**Subject:** [EXTERNAL] Re: 19511 Shrewsbury - HDC application

I reviewed the application materials for the proposal to replace the tile flooring at the front entrance, and I have the following questions:

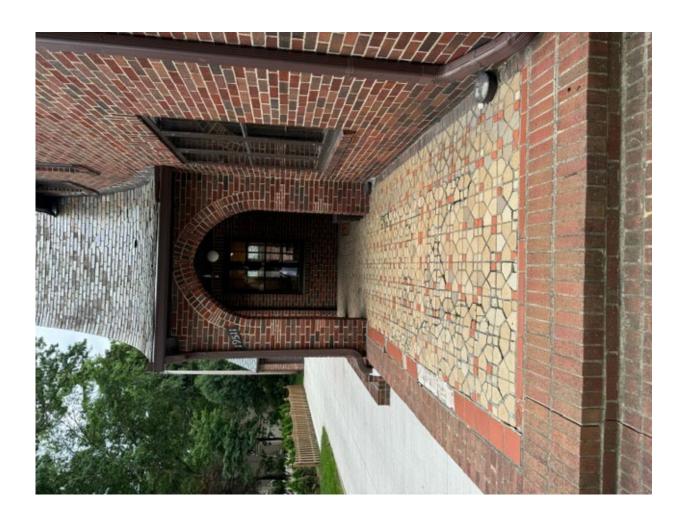
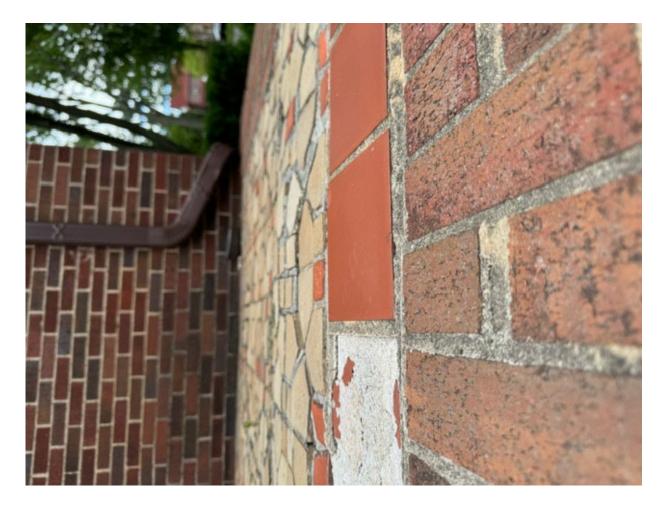
I first need to explain that this is not just the front entrance. I need to replace the entire porch because the tiles are broken and deteriorating as a result of almost 100 years exposure to the snow and ice. As a matter of fact, the front entrance is fine, because it is covered by a roof. But, we obviously can't do a partial replacement, so we'll have to replace the entire area. Here are some pictures to show you what I mean:

--Please submit additional photos of the porch floor, include side views and views showing the entry porch stairs.

See above.
